**Re: Notice of Violation
Fairfield Union HS / Fairfield County**

This letter is written in follow-up to a construction storm water inspection that I conducted at the Fairfield Union High School located at 6401 Cincinnati-Zanesville Road near Rushville, Ohio on December 7, 2009. The purpose of the inspection was to evaluate compliance with the General Storm Water Permit Associated with Construction Activities. During the inspection, the following items were noted:

Fairfield Union HS
Stabilize barren areas
Rush Creek Watershed
December 7, 2009
Photo by: Greg Sanders

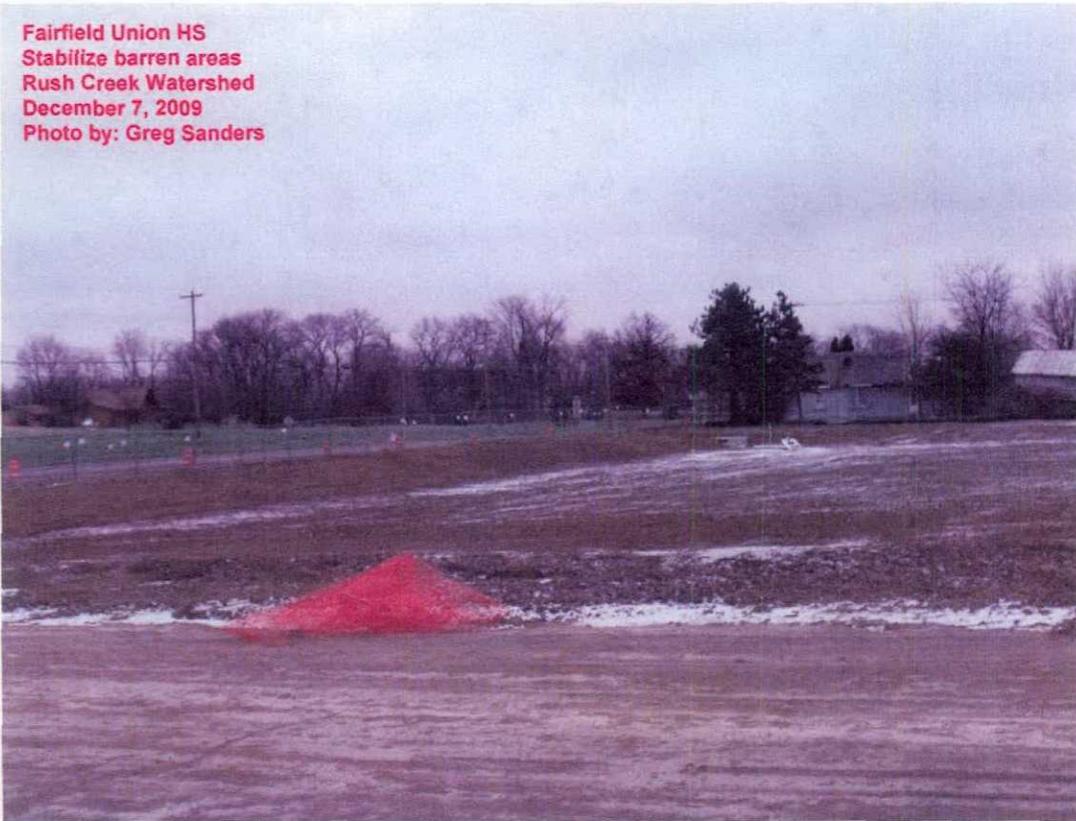
- Be aware the General Permit states that all barren areas which remain idle in excess of 21 days must be protected from erosion within seven days of the last earth disturbing activities. In addition, erosion protection must be implemented for all areas of final grade within seven (7) days. This regulation directly applies to the areas along Cincinnati-Zanesville Road in front of the old school. Several areas have been barren for several months. Please see attached pictures.
- Winter Rule: Considerations must be made at this time to ensure all barren areas are protected from erosion in preparation for the upcoming winter months. Please note that seed and straw will most likely not work at this time due to the effective growing season has ended. Alternative erosion protection will be required to fully stabilize the area for winter. (i.e., erosion control matting or crimp mulching).

Fairfield Union HS
Need concrete wash out pit
Rush Creek Watershed
December 7, 2009
Photo by: Greg Sanders

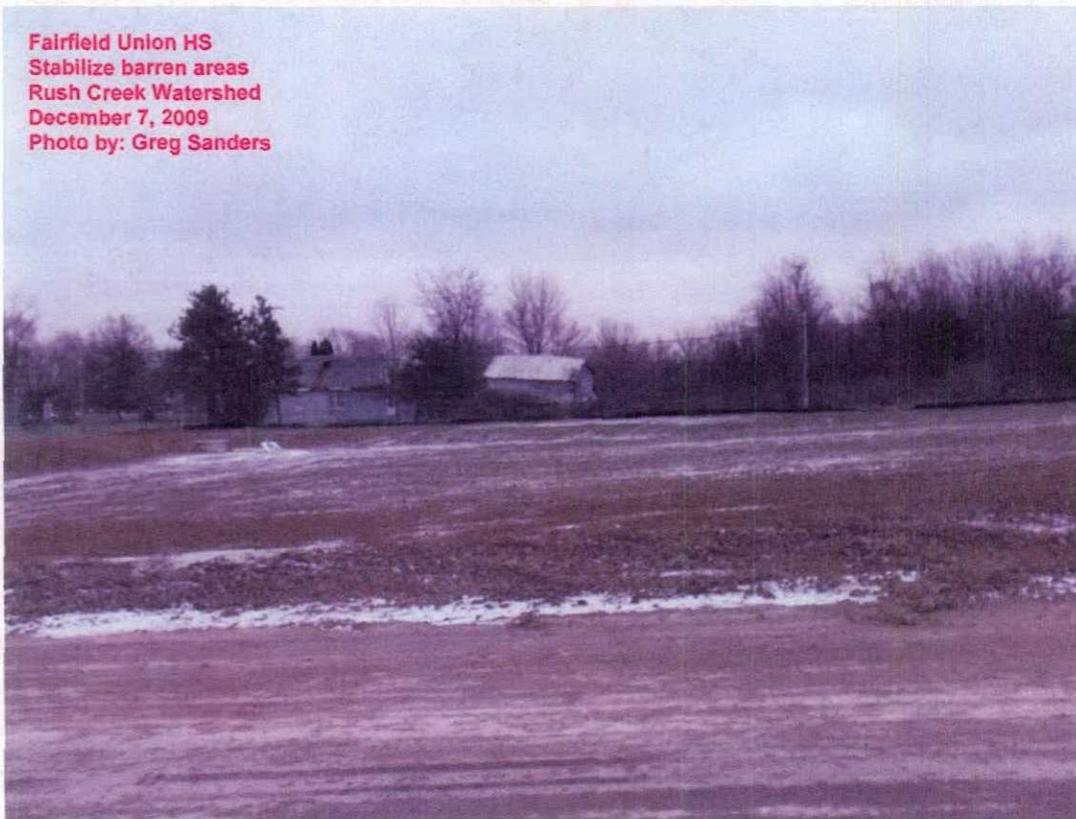
- Please be aware that a concrete wash out pit needs to be constructed for the disposal of concrete wash out waste. During the site visit, concrete wash out waste was being discharged to the ground and flowing into a roadside ditch. Please see attached picture.
- **Post Construction Requirements:**
- The General Storm Water Permit requires specific post construction water quality treatment for all sites. Guidance regarding the post construction requirements are found at:
<http://www.epa.state.oh.us/dsw/storm/CGPPCQA.aspx>. Please submit to my attention (email preferred at greg.sanders@epa.state.oh.us) which practice will be installed at this site to ensure compliance with the General Permit. Please include all design criteria and calculations in your submission.
